# 1955 PITTWATER ROAD, BAYVIEW

S4.55 AMENDED PLANS

DRAWING LIST

Drawing Title  
**Lower Ground Floor Plan**

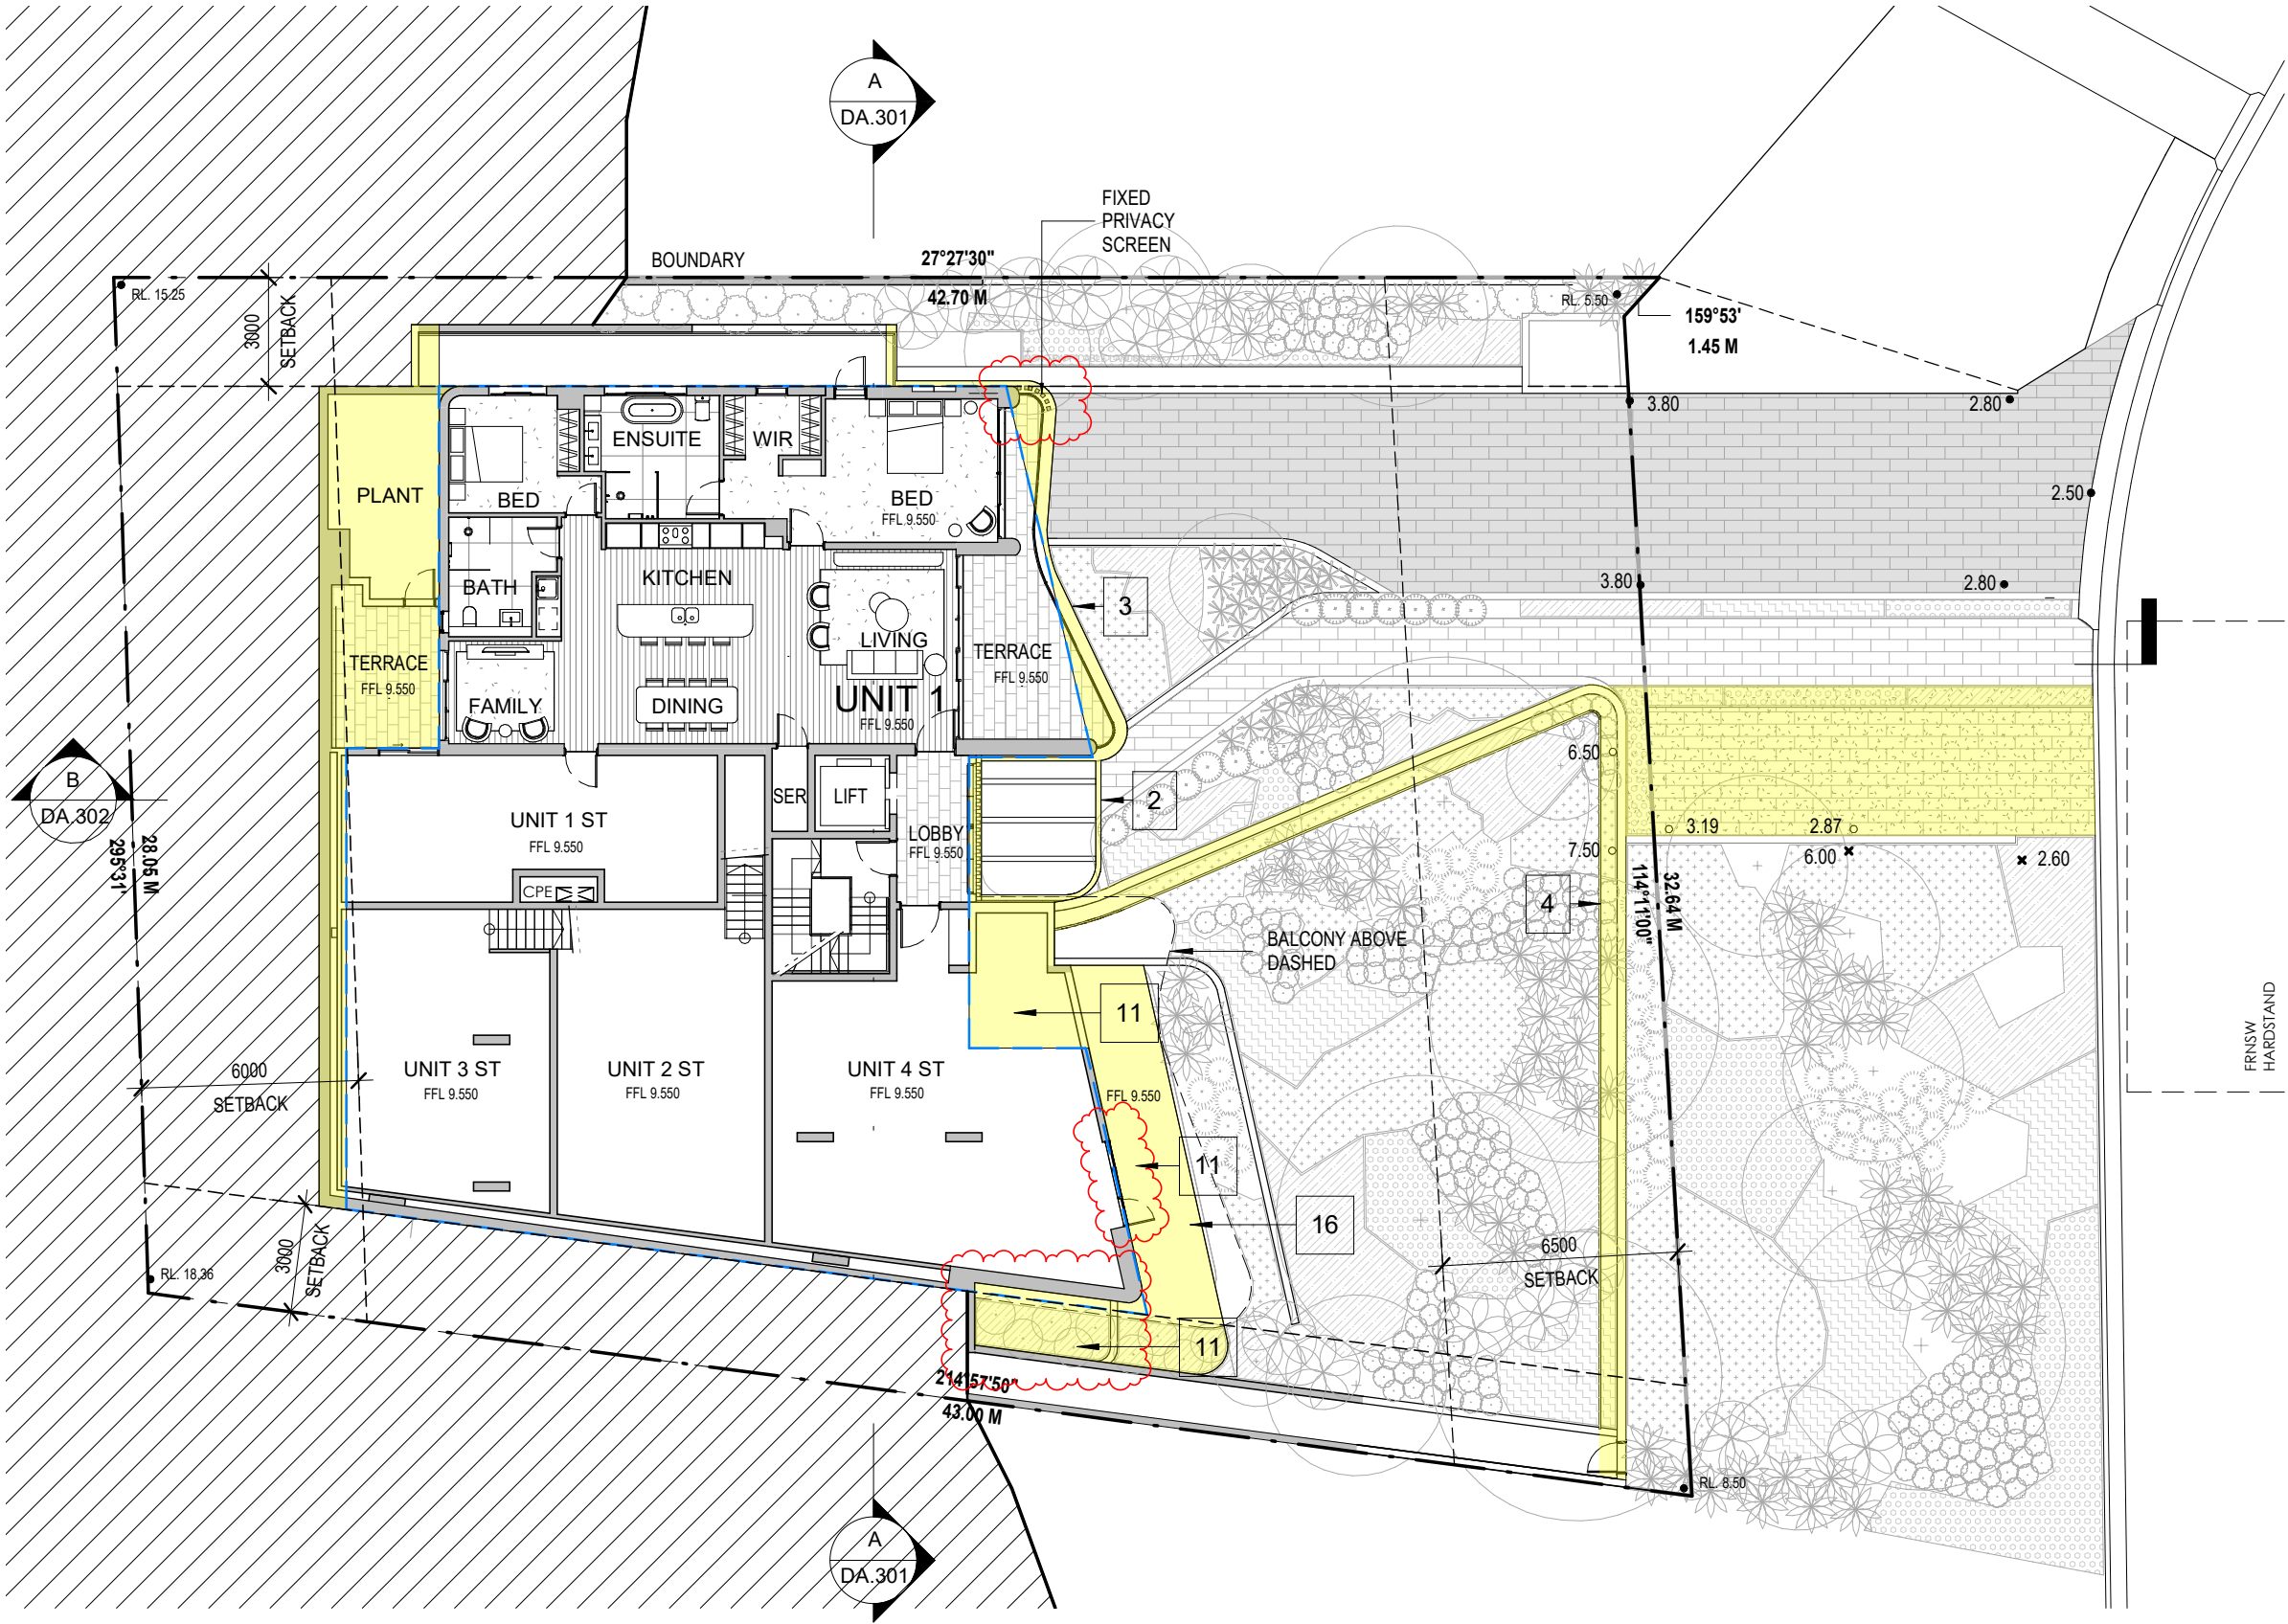
- 11. **Lower Ground Floor Plan** – Increase in Unit 4 storage area to accentuate recess and alignment between the two modulated built forms. Louvred door and panels for maintenance and ventilation. New landscaped terrace to integrate with cascading balconies above and overall building aesthetics.

Drawing Title			Project No.
Ground Floor Plan			A22039
SCALE	1 : 200	@ A3	Drawing no: DA.204
			ISSUE C

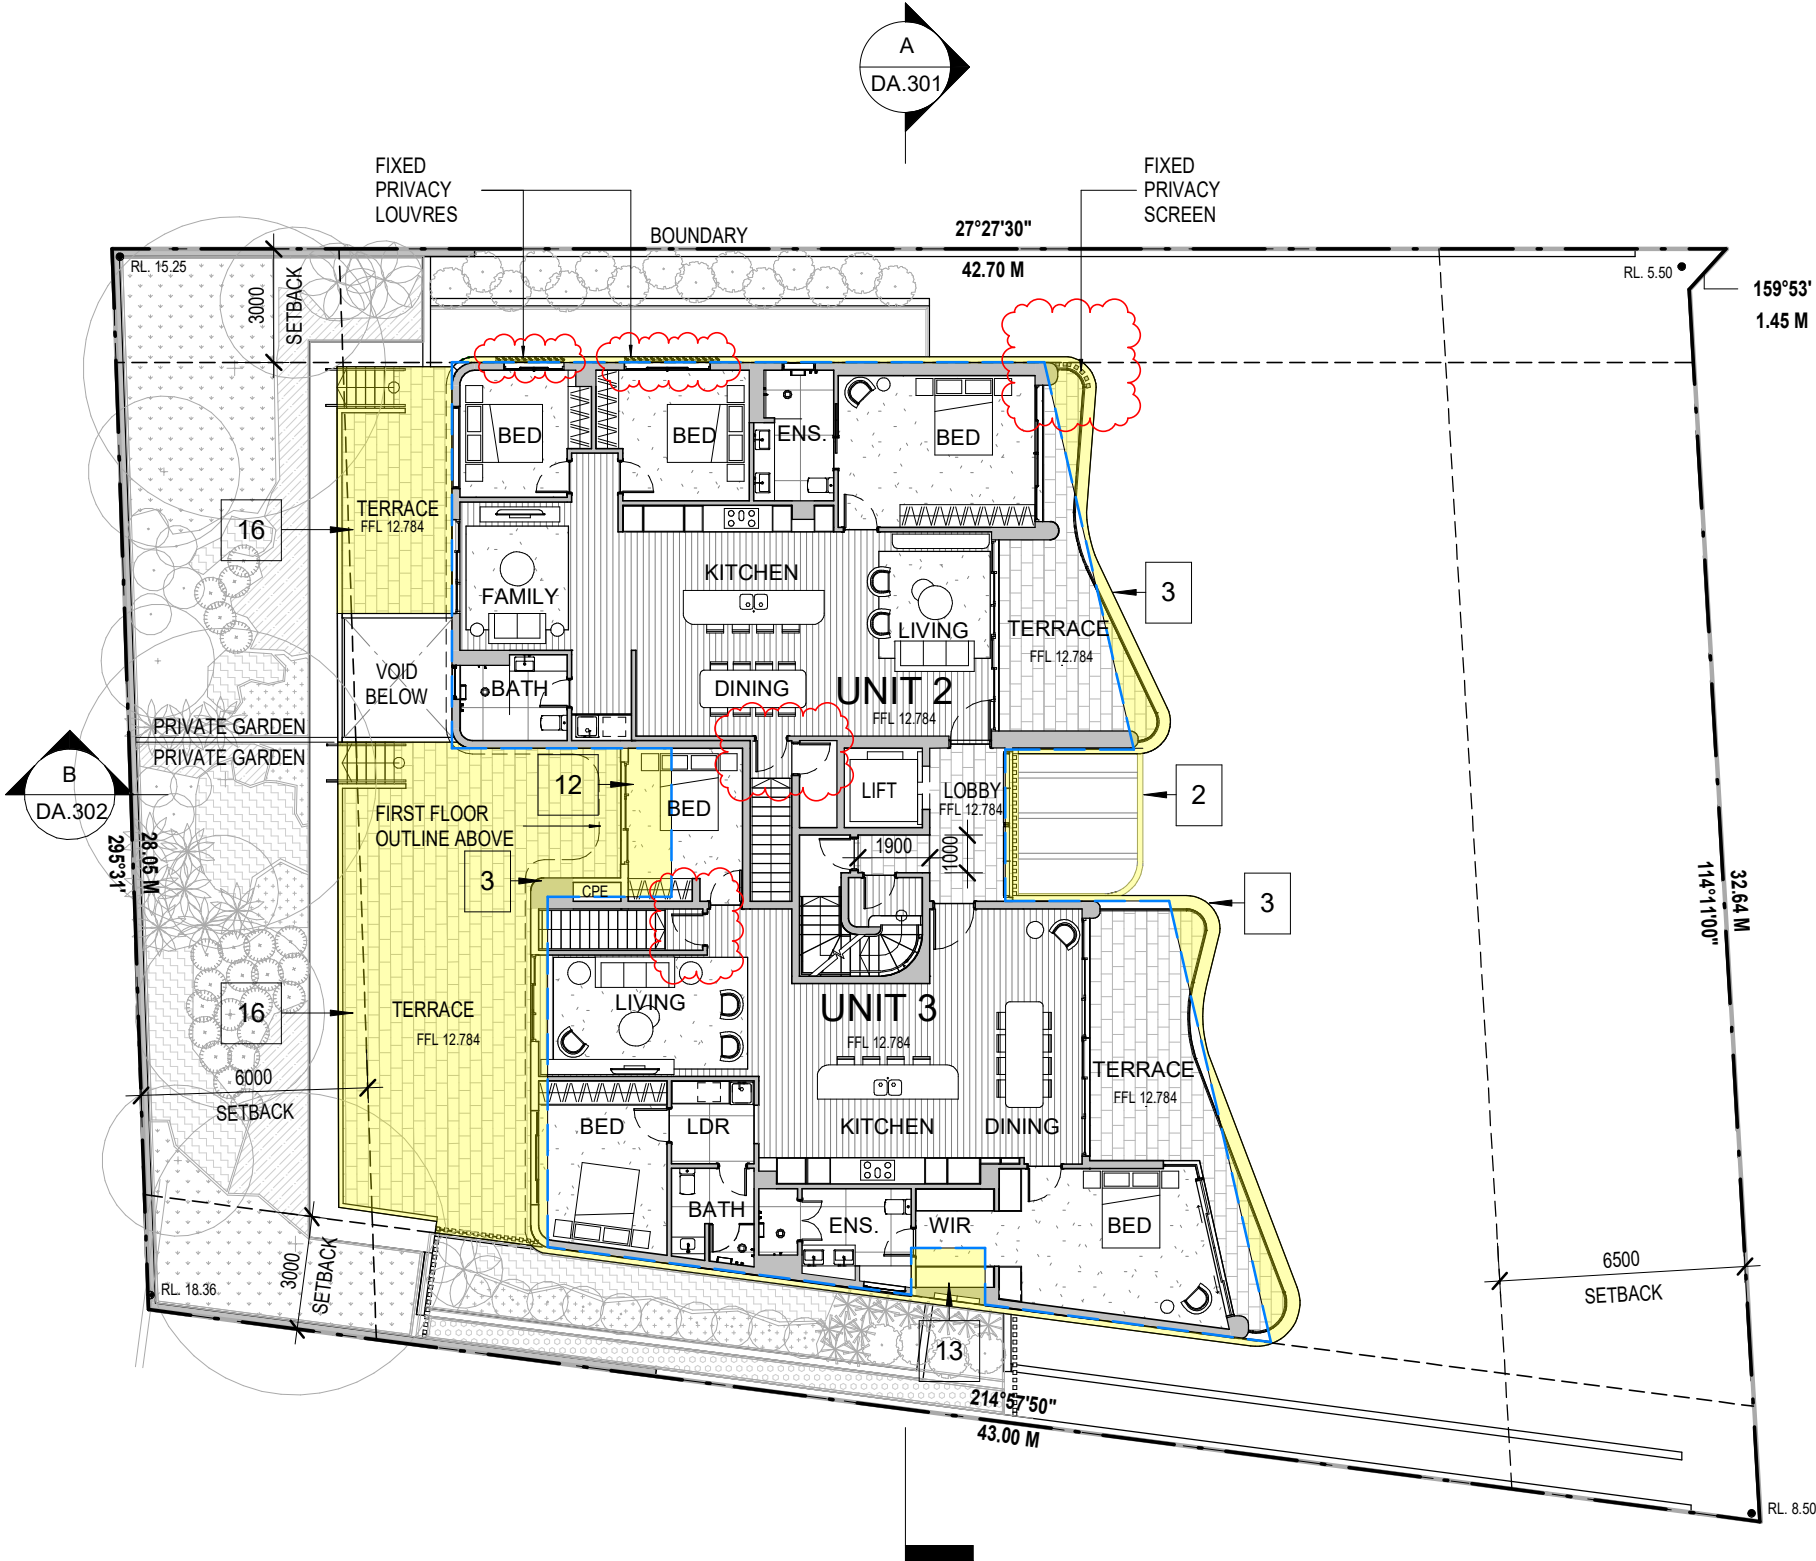
1. **Entry Pedestrian Ramp** - Increased pedestrian ramp width to 1600mm for accessibility
2. **Building Entry** - New awning and vertical louvre screen to increase sense of entry.

3. **Balcony Articulation** - New curved balconies for improved aesthetics. Increase in outdoor private open space area and solar access for improved amenity

12. **Unit layouts** - Internal reconfiguration and increase in unit size for improved amenity.
13. **Elevations** - Removal of wall break in east elevation of Units 3 and 4. Revised façade and window treatments associated with plan amendments

Drawing Title  
First Floor Plan

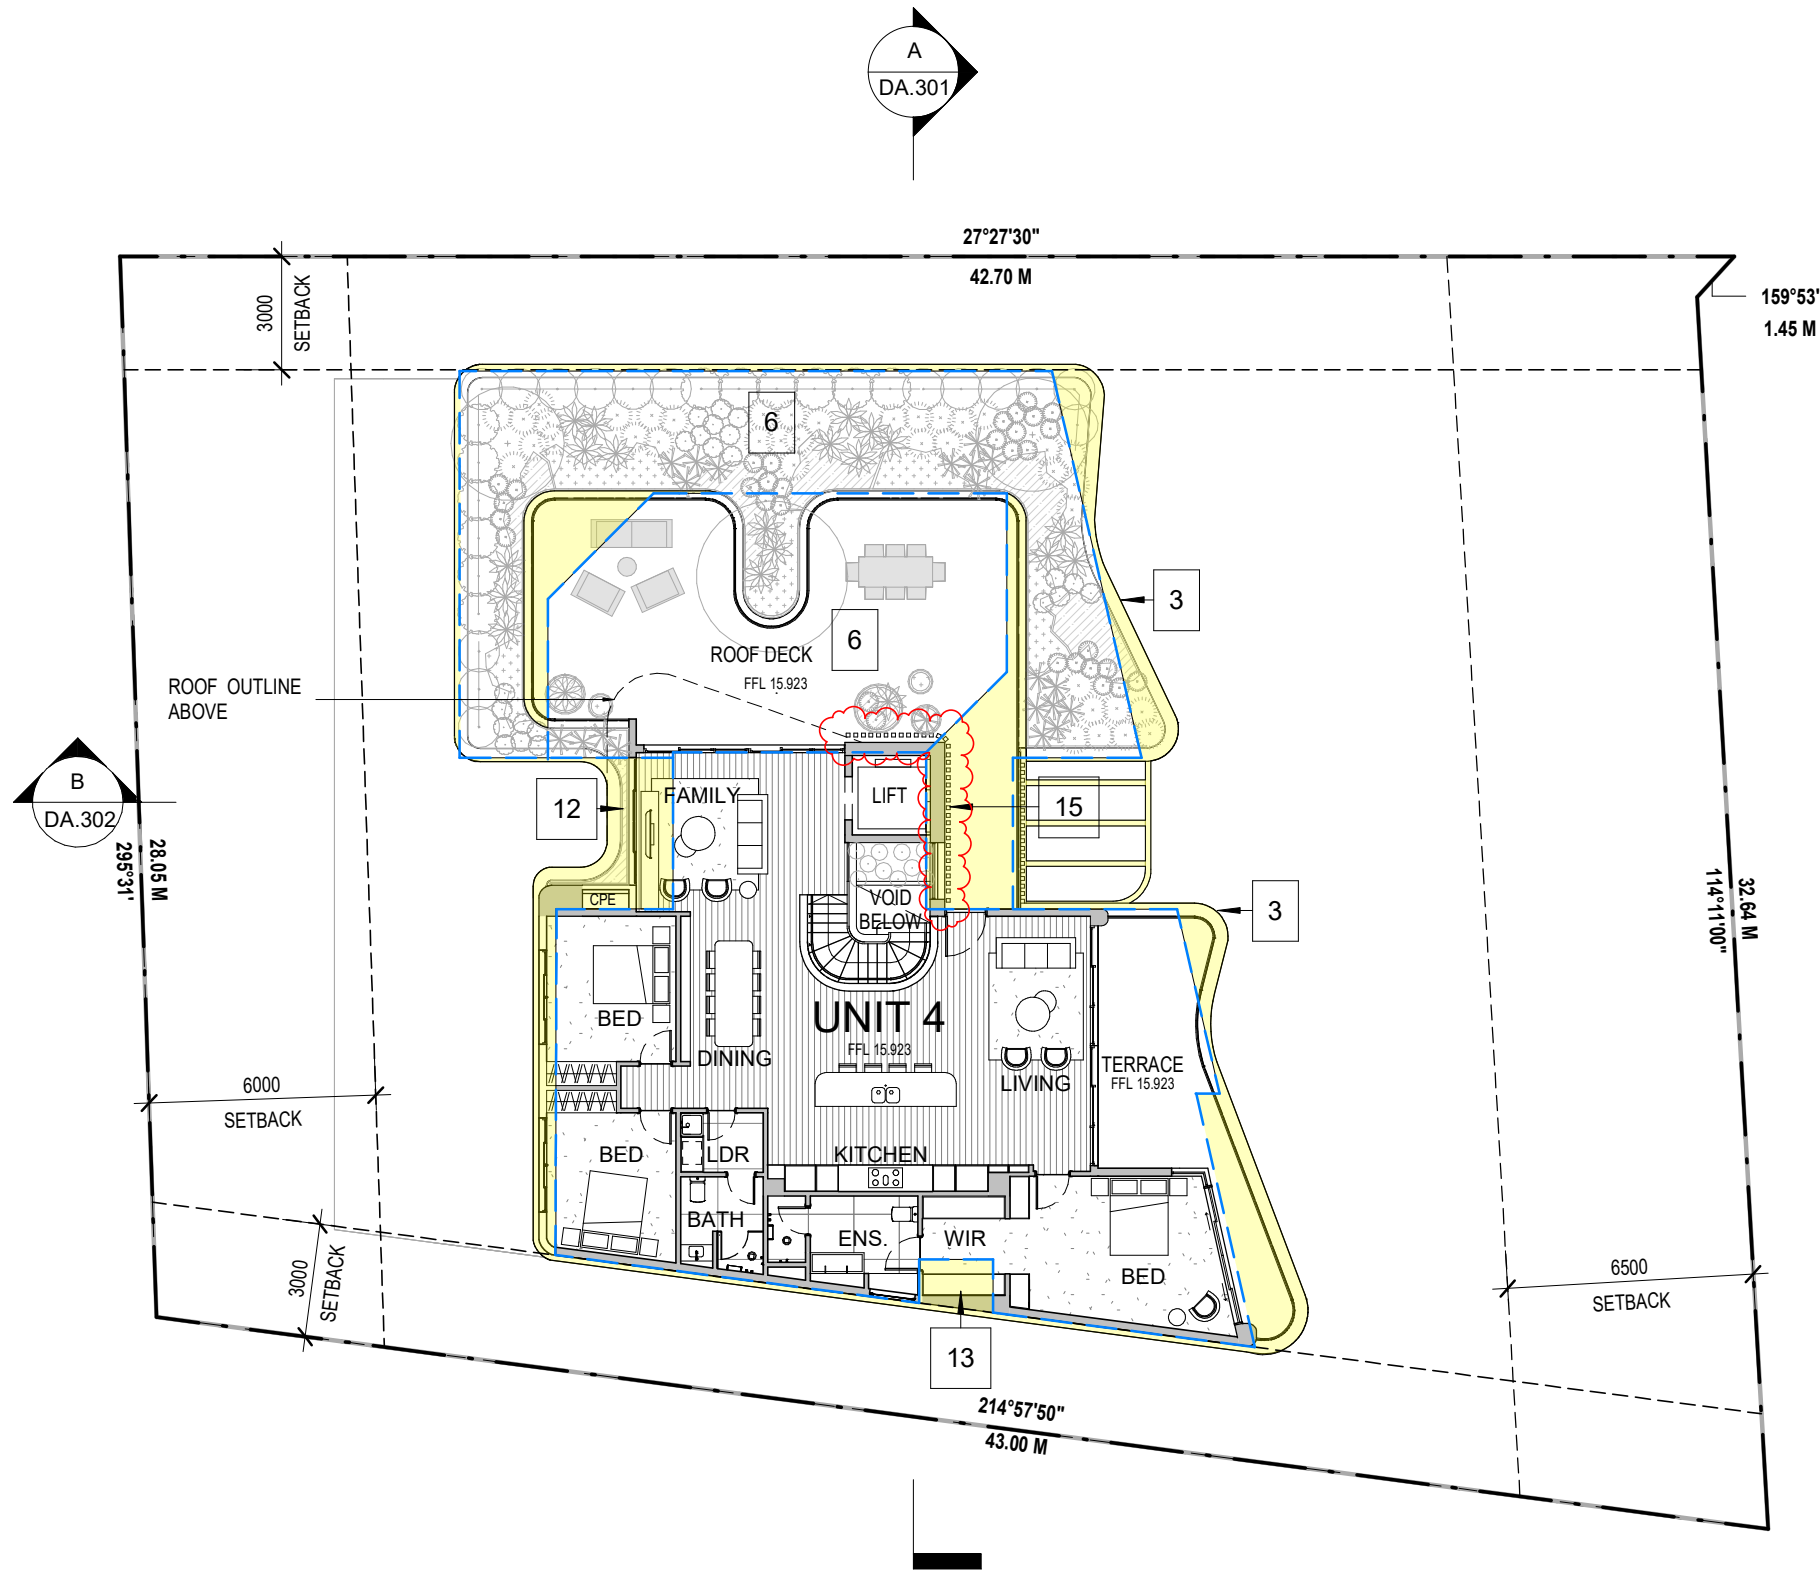
4. **Fencing** - New fencing to provide safety and security
5. **Roof** - New rooftop plant enclosure to comply with services requirements
6. **First Floor Roof Deck/ Landscaping** - Change in configuration of First Floor roof deck to integrate with overall building aesthetics. New landscape buffer around perimeter of First Floor roof deck for improved privacy and softening of built form
